Re: Initial Submission Review – Murphy Creek PA 16 & 20 – Site Plan w/ Adjustments, Plat
Application Number: **DA-1250-48**
Case Numbers: **2020-4020-00**

Initial Submission Review

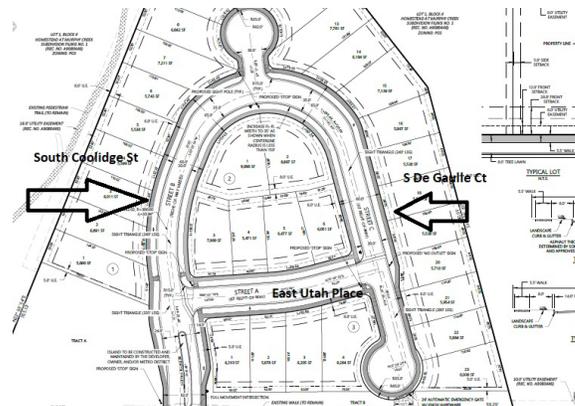
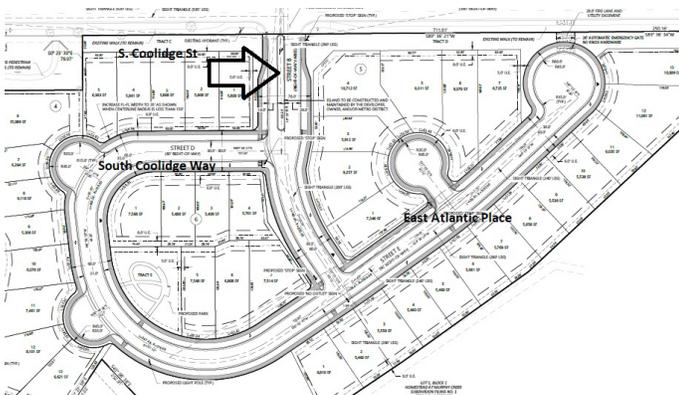
The following are the street names that are assigned for this project:
